## ADDENDUM NO. 1

Reference: Forward Operating Base – Camp Williams  
Utah National Guard – Riverton, Utah  
DFCM Project No. 07326480

**ADDENDUM NO. 1**

# Addendum #1

3r SECTION  
 SCALE: 1/4" = 1'-0"

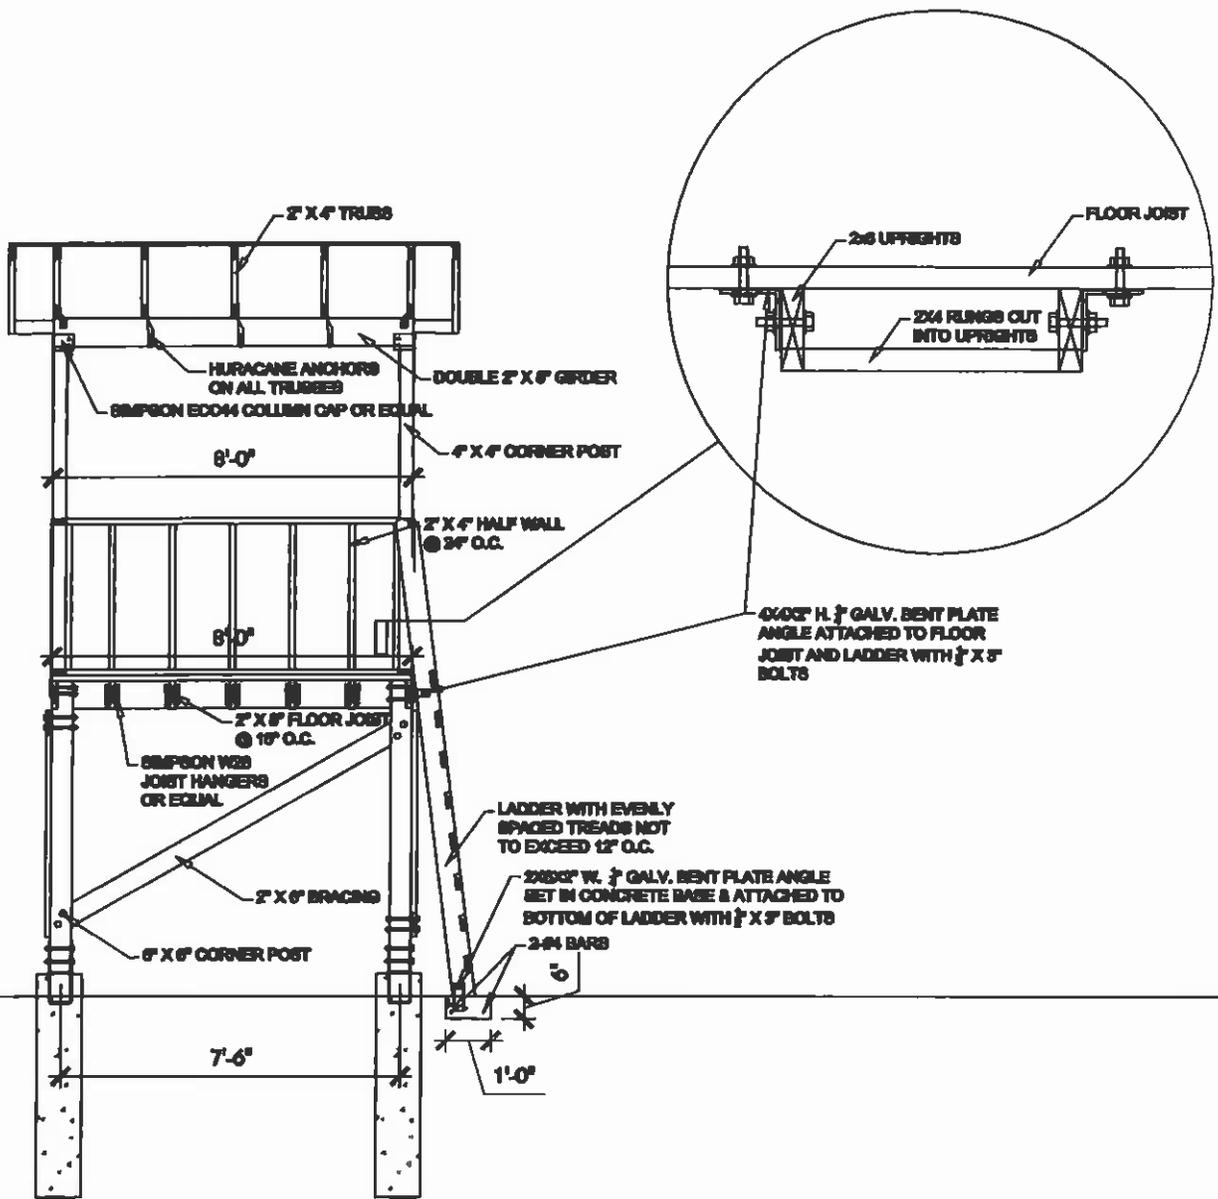
1. Replace Section 3/AE201 with the attached revised Section 3r/AE201.

DETAILS FOR THE LADDER CONSTRUCTION HAVE BEEN ADDED TO CLARIFY THE SIZE OF THE UPRIGHTS, RUNGS AND ATTACHMENT TO THE TOWER

**EE-501-R1-01**

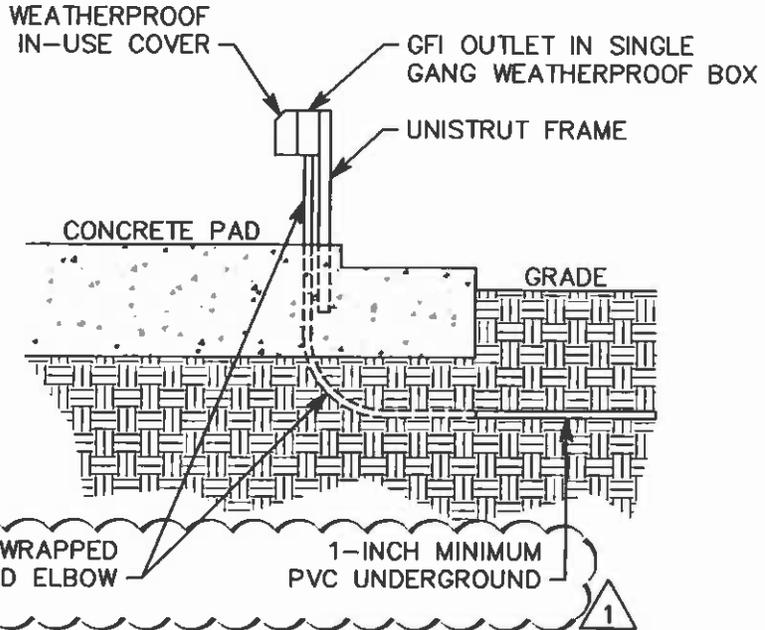
1. Conduit sizing on detail H18 shall read "1-inch minimum" in lieu of "1-inch". Sketch EE-501-R1-01
2. One-line diagram: remove the transformer that is not identified with a size. Move the connection from the 225 kVA transformer to the MSB to be from the secondary of the transformer (off the bottom). Sketch EE-501-R1-02

2. See EE501. Detail H18 indicates that the branch conduit size for the weatherproof receptacles is 1". If you look at ES401, some of the conduits are ¾". With the wires that are called for ¾" will do fine. For those locations that are fed with a ¾", I propose to change the detail accordingly. Is that acceptable?

**Provide all underground conduits 1-inch minimum diameter. Provide larger diameter conduit as indicated.**

**EE-501-R1-02**

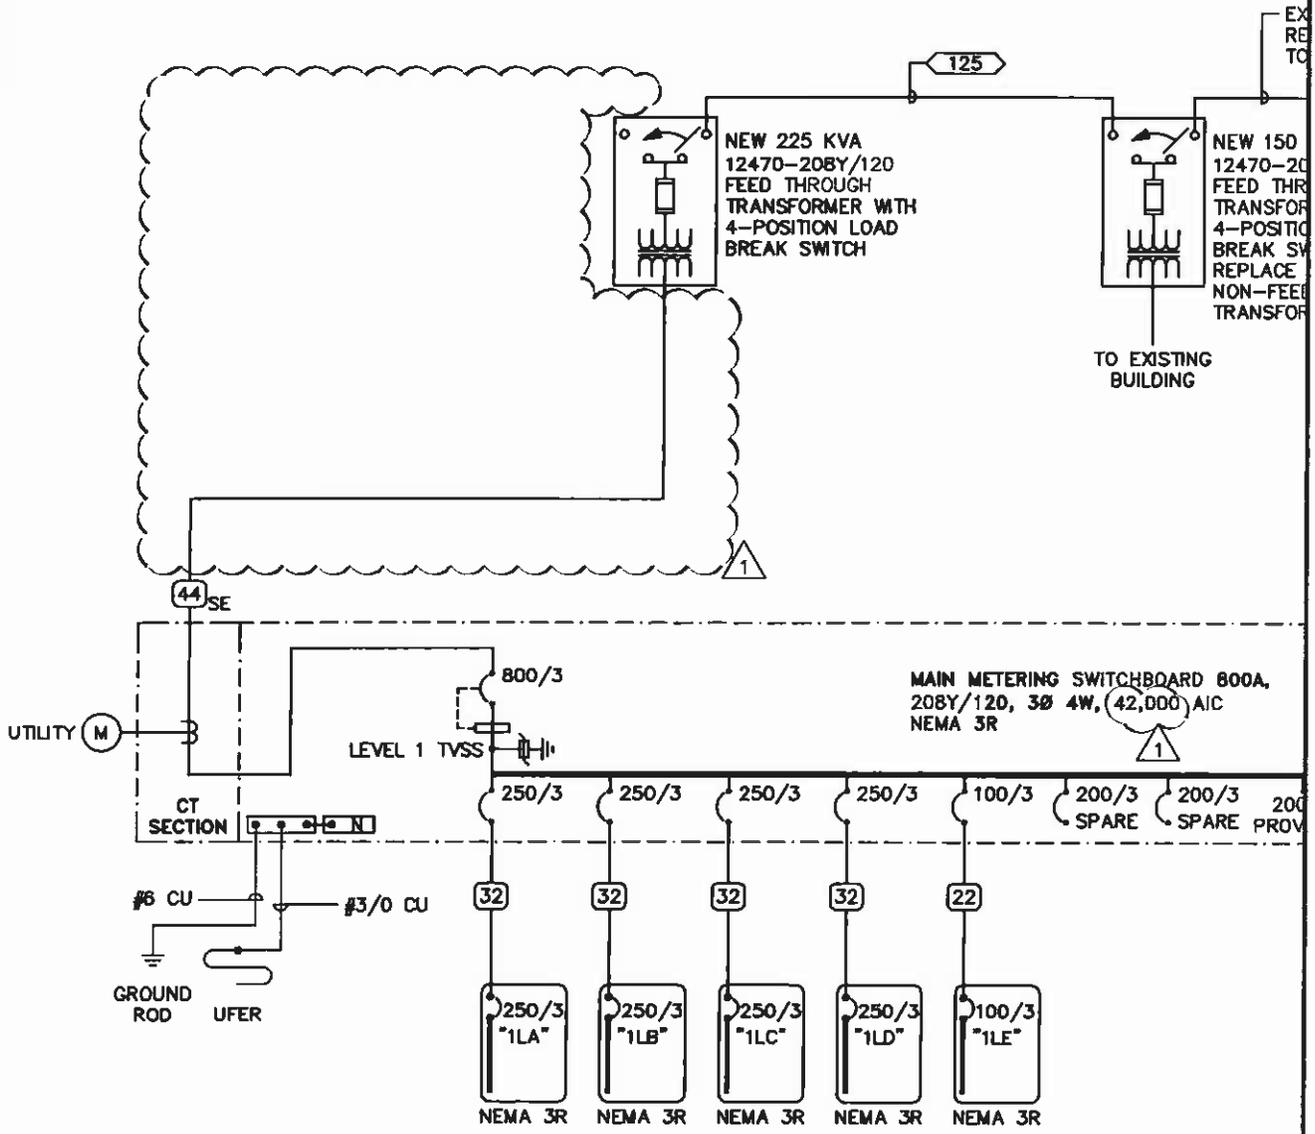
1. See EE501. Detail 12 shows a new 150 Kva transformer at the building, then a new 225 Kva, then another that does not have a size shown. It looks like the one without the size is actually the 225 Kva installed within the FOB. Please confirm that.

**There are only (2) transformers, the 150 kVA feed through transformer to replace the existing 150 kVA at the existing building and the 225 kVA transformer serving the FOB. The other transformer you see on the one-line diagram is not part of the project and has been removed. See the notes above.**
